METROLINK,

REF. ABP-314724-22

## TECHNICAL REVIEW

Final Report

Figure 4 Typical Deep Station illustrating permanent and temporary propping (extract from Chapter 5 Fig 5.25)

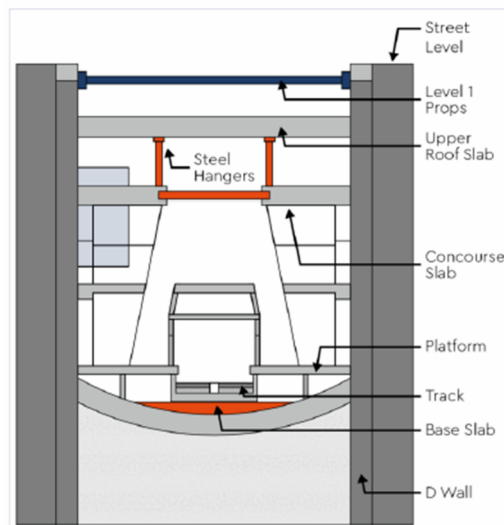
For the deep stations of the MetroLink these settlements will be small as the Applicant has committed to a “top down” construction sequence, where the permanent roof slab of the station is constructed prior to excavation. This is illustrated in the EIAR Chapter 5 Figure 5.25 shown below.

This results in a relatively stiff retaining wall system and, as the soils are predominantly stiff, low settlement should be experienced from the deep station excavations. However, this is not a commitment by the Applicant in the cut & cover and retained cut sections of the tunnel and there may therefore be larger excavation induced settlements in these areas. Settlement may also be caused by groundwater lowering, where the effective stress is increased due to the groundwater lowering, or there may be settlements induced by the compression of organic soils. These issues are dealt with in Section 5 Hydrogeology above.

Figure 5 Phase 1 Settlement Predictions Mater Station (extract from OH300 Sheet 22)

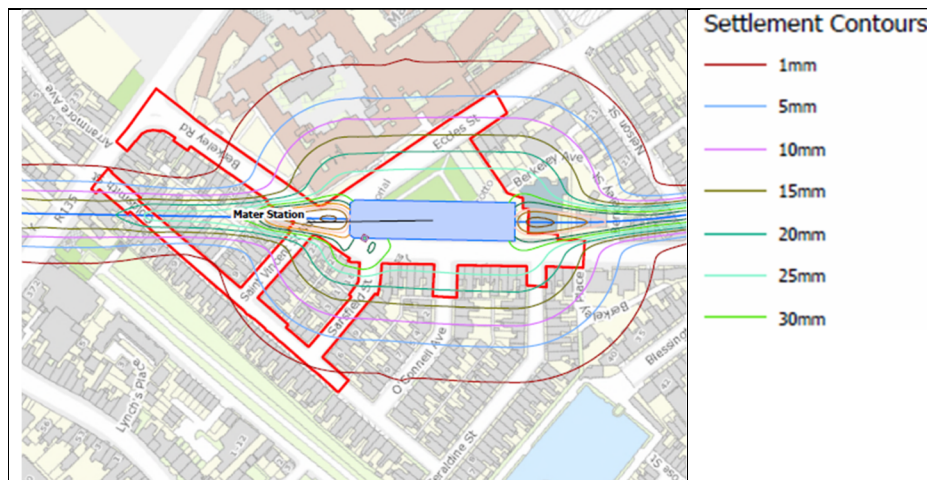
For the example of Mater Station shown in Figure 5 above, it indicates approximately 40 mm settlement for St. Joseph's Church (building denoted B-101 in A5.17) at the Southern end of the box and 30 mm at the corner of the Mater Hospital building at the Northern end of the box. The Applicant has committed that appropriate measures will be put into place for the entry and exit of the TBMs through the deep stations such as Mater and has addressed this in OH116 submitted on Day 8 with a generic note describing the Applicant's intentions for the break-in and break-out of stations boxes. However, it is likely that St. Joseph's Church, which is just above the break-out of the Mater Station box and thus sensitive to any ground losses caused by the break-out and ensuing settlement, will need some careful consideration. It is likely that tailored mitigation measures will need to be put into place to ensure that no building damage beyond Category 1 is caused.

Figure 6 Charlemont Settlement (extract from OH300 sheet 28)

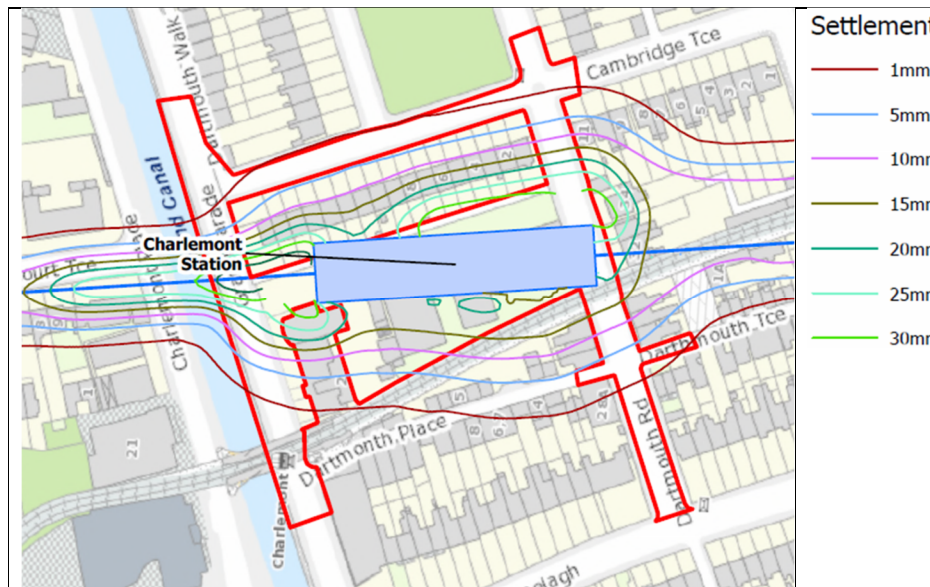
Concerns were raised regarding Soils and Hydrogeology and settlement, particularly for the houses located in Dartmouth Square West, Cambridge Terrace and Dartmouth Road.

These properties are located adjacent to the proposed Charlemont Station, where they will be influenced by the station box construction and a shallow extension of the box. The greenfield settlement prediction given on drawing No. ML1-JAI-EIA-ROUT\_XX-DR-Y-21147 (OH300) indicates (also shown in Figure 5) that the residential properties on Dartmouth Square West are close to the station box and have predicted settlements of approximately 20-30 mm which may cause some damage beyond cosmetic damage as a result.

Mr. Paul Quigley and Mr. Brian Kavanagh gave presentations on their review of the Applicants documents, focusing on two themes covering the Dartmouth Square West properties: Building damage and hydrogeology. Mr. Quigley expressed the view that the Applicants strategy for the handling of geotechnical risks was inadequate given the stage of the project and that excessively high settlements are predicted and are not adequately mitigated. Mr Quigley also expressed concern regarding the Applicants approach to building damage risk, that results in the detailed assessments not being carried out until late in the process by the D&B Contractor which is essentially shortly before construction commences.

Figure 8 Two concepts for the TBM to pass through the station box. Left: TBM before base slab; right: TBM after base slab (Chapter 5, Diagram 5.26)

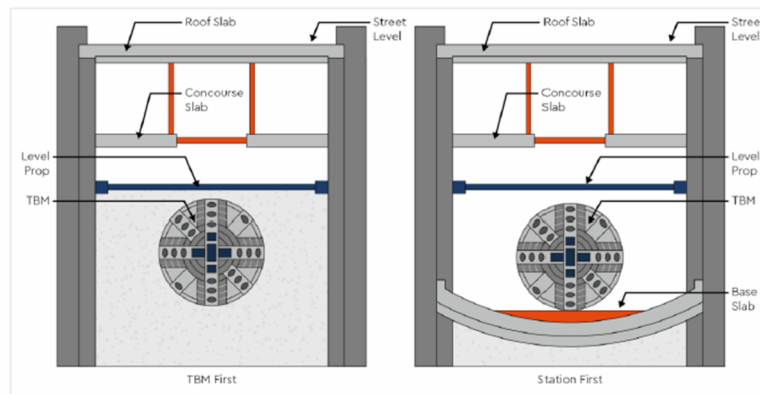
The two methods are described above and illustrated in Figure 8 i.e. TBM crossing the stations before or after base slab construction, both methods proposed are established engineering practice in metro construction.
